DATE: May 9 2011 ARC REVIEW CODE: R1105091

Name of Proposal: Shugart Farms Lake Park

SHUGART FARMS LAKE PARK DRI City of Fairburn Environmental Planning Division Review Comments

TO:	Jon Tuley, Land Use Division					
FROM:	Patrick Bra	Patrick Bradshaw, Transportation Planning Division				
DATE: SUBJECT:	Project: County:	ew of DRI # 2181 Shugart Farms Lake Park Fulton East of Bohannon Road and north of I-85 in Fulton County Expedited Non-Expedited X				
cc:	David Hay	nes

JAND LOT 28,31&32 9th DISTRICT OF FAIRBURN, GEORGIA FARMS LA DRI #2181

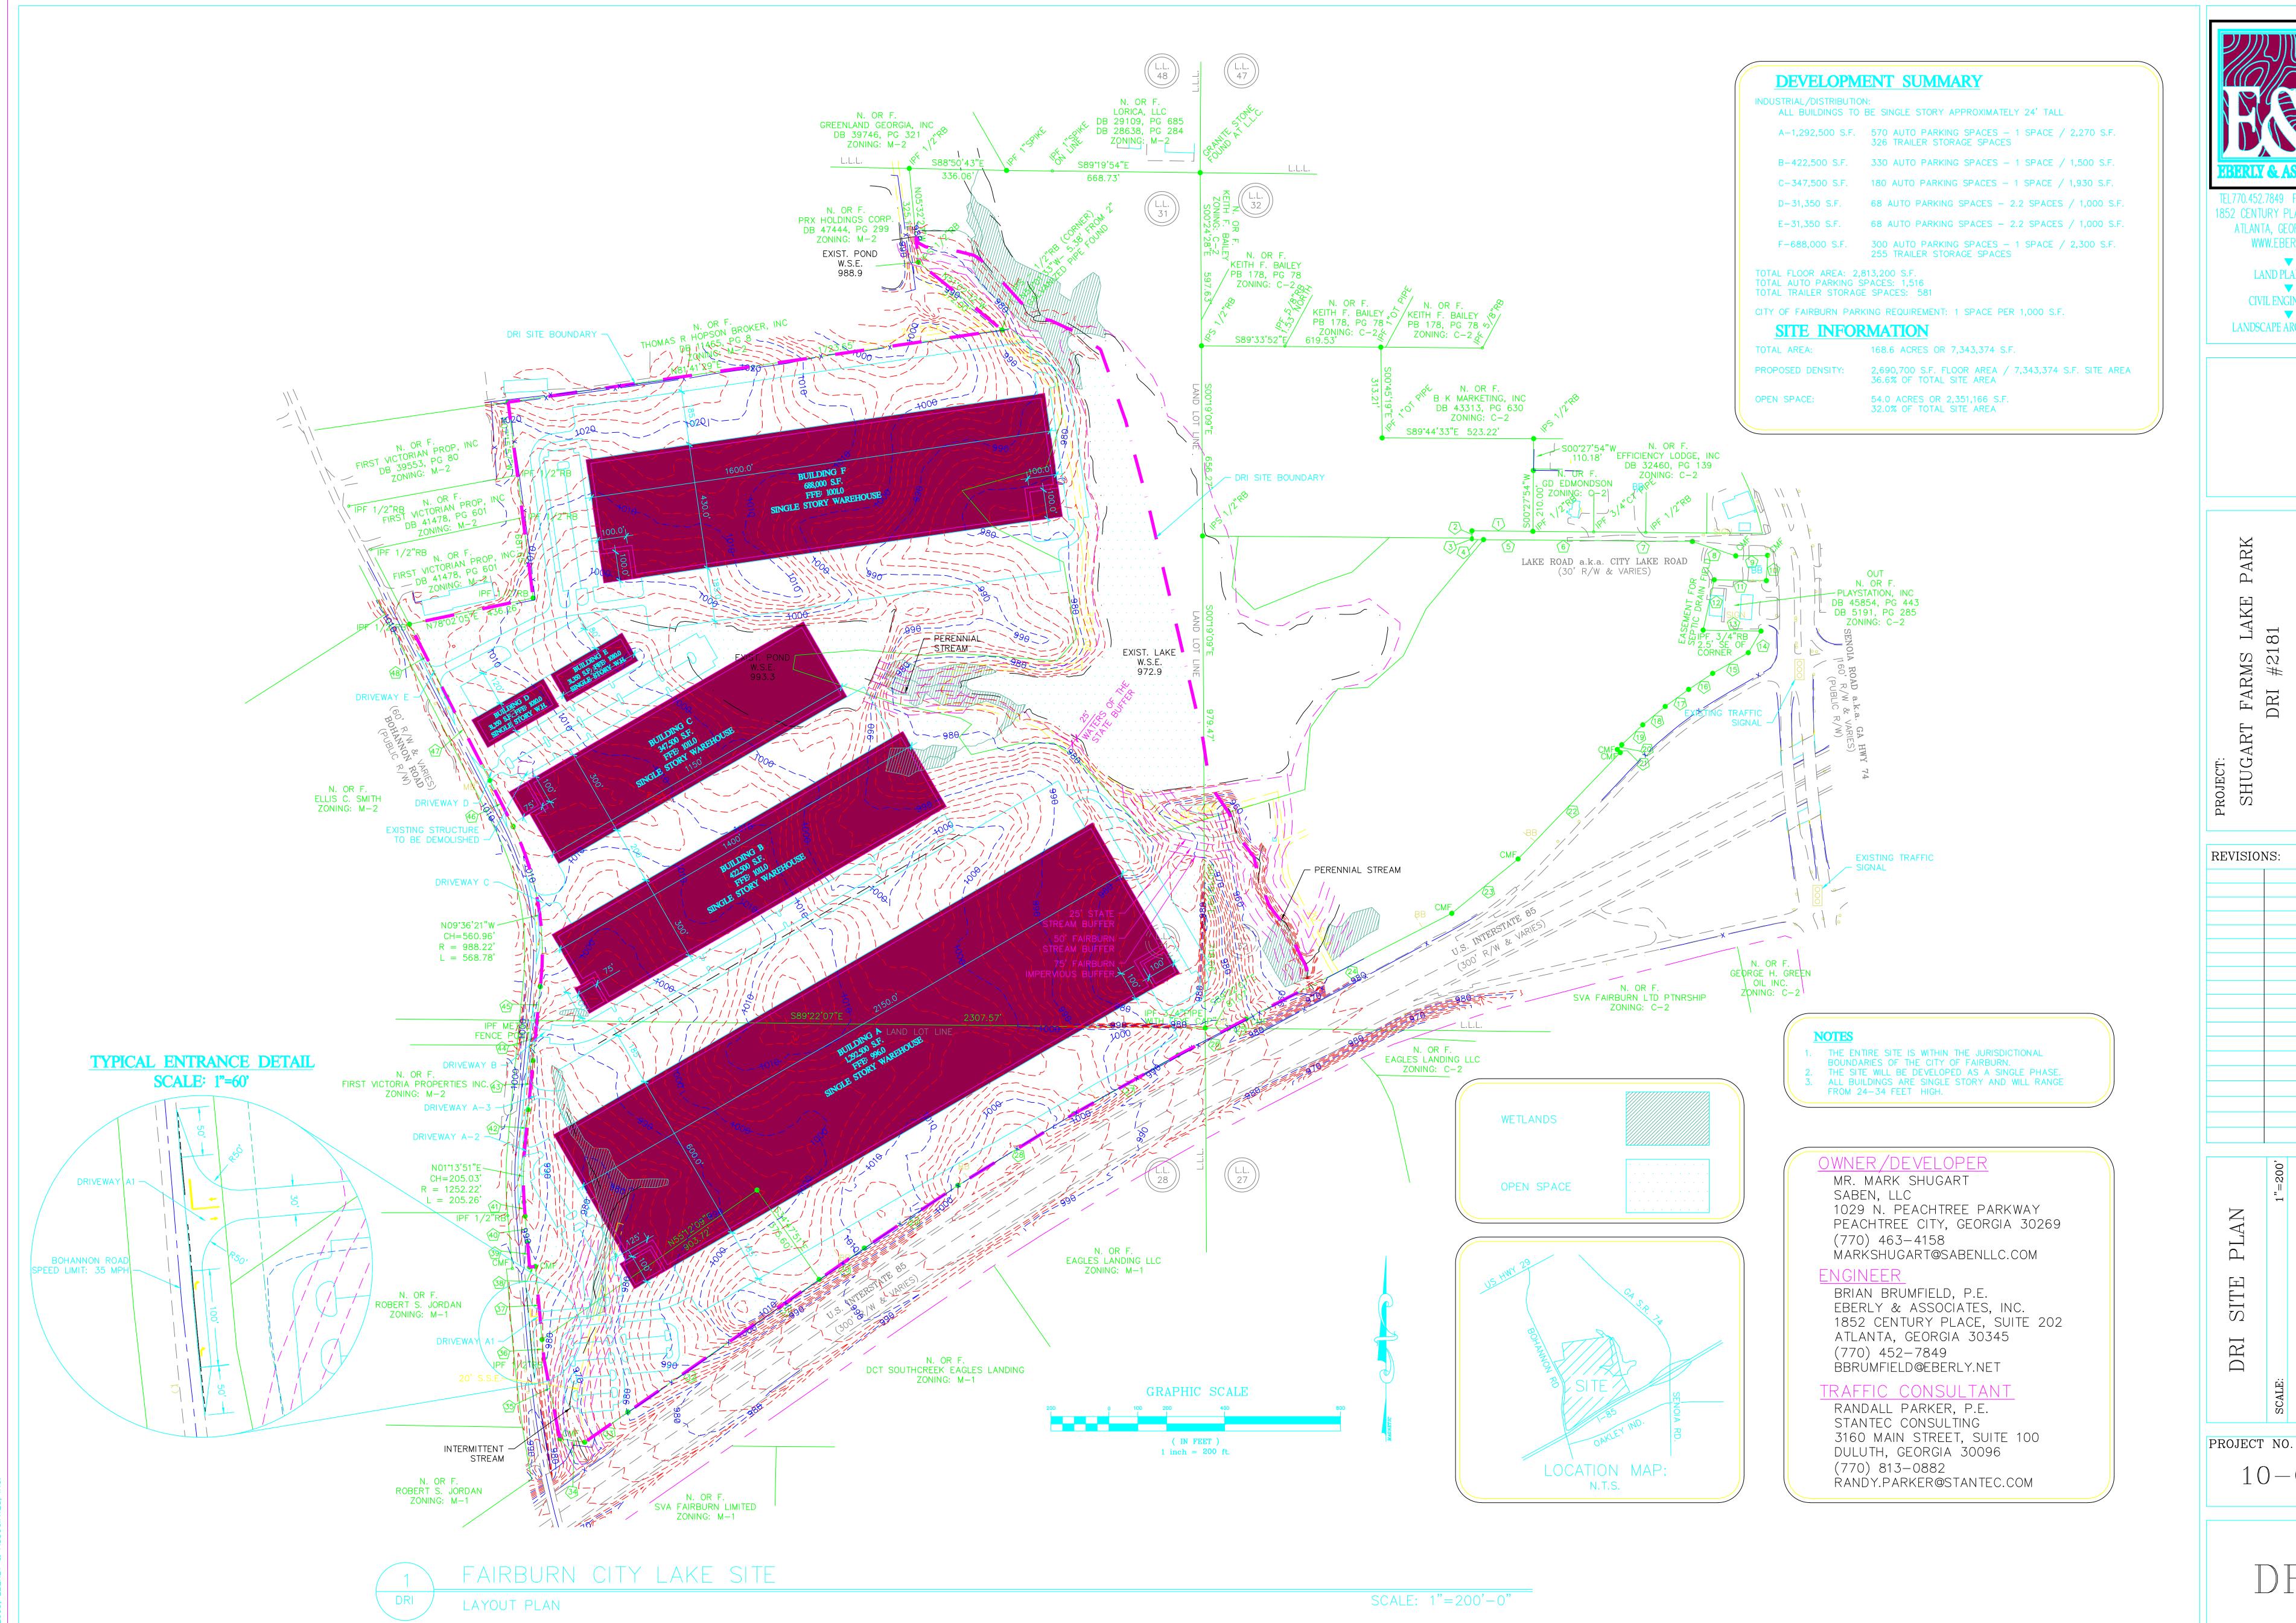
The proposed project site plan shows Building A and parking over the unnamed tributary along Bohannon, intruding into the 50-foot buffer and 75-foot impervious setback required under the Water Supply watershed Criteria. In addition, part of Building B is shown as adjacent to the plan-identified perennial stream and part of Building C is shown as being over the existing pond on the property, and may affect Water Supply Watershed buffers and setbacks. The proposed structures and impervious surfaces also intrude on the City Stream Buffer ordinance's 75-foot stream buffer and the State 25-foot Sediment and Erosion Control Buffer. Any other waters of the state on this property will also be subject to the State buffer.

The proposed project site plan shows Building A and parking over the unnamed tributary along Bohannon, intruding into the 50-foot buffer and 75-foot impervious setback required under the Water Supply watershed Criteria. In addition, part of Building B is shown as adjacent to the plan-identified perennial stream and part of Building C is shown as being over the existing pond on the property, and may affect Water Supply Watershed buffers and setbacks. The proposed structures and impervious surfaces also intrude on the City Stream Buffer ordinance's 75-foot stream buffer and the State 25-foot Sediment and Erosion Control Buffer. Any other waters of the state on this property will also be subject to the State buffer.

The City will need to determine if the proposal meets the Water Supply Watershed Buffer Criteria. The City will also need to determine if the proposed project is within the 25 percent impervious coverage requirement for the City's portion of the basin, or meets any alternate criteria that have been developed and approved. The city will need to determine if the proposed project is eligible for variances under the City Stream Buffer Ordinance and the State Sediment and Erosion Control Buffer requirements.

The City will need to determine if the proposal meets the Water Supply Watershed Buffer Criteria. The City will also need to determine if the proposed project is within the 25 percent impervious coverage requirement for the City's portion of the basin, or meets any alternate criteria that have been developed and approved. The city will need to determine if the proposed project is eligible for variances under the City Stream Buffer Ordinance and the State Sediment and Erosion Control Buffer requirements.
